July 31, 2019

To: California Department of Water Resources

Re: Comments on First Negotiation Session on Delta Conveyance Amendment

Figure 2-3 Detail of finite element mesh modifications for 50 breach simulations (with Sherman Island breached).

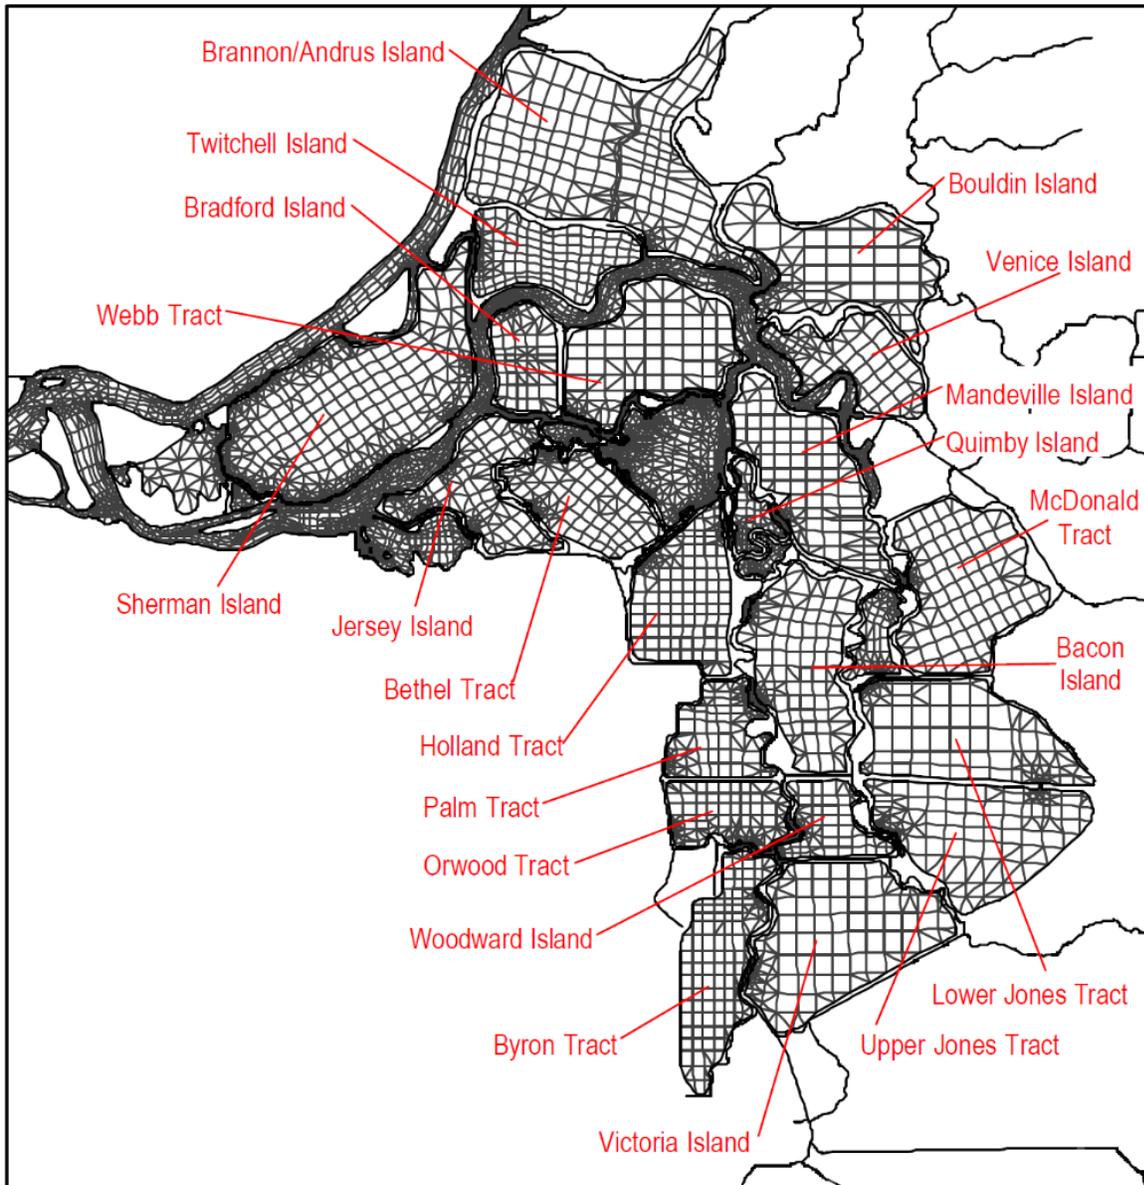
There are also problems with the RMA analysis of the impacts of levee failure in the Delta. The analysis of operations with sea level rise and large scale levee failure was a modification of RMA’s simulation of the Hayward scenario earthquake for the Delta Risk Management Strategy. The simulation used a grid³ which only includes levees as far north as Bouldin Island. (See below.)

There was no analysis of operations of the project with levee failure north of Bouldin Island. There is potentially significant salinity intrusion with low Sacramento River flows if there was large scale levee failure due to sea level rise. While the US Geological Survey lists Hood’s elevation as 7 feet, the bottom of the Sacramento River in the vicinity of Hood can be over 20 feet below sea level.
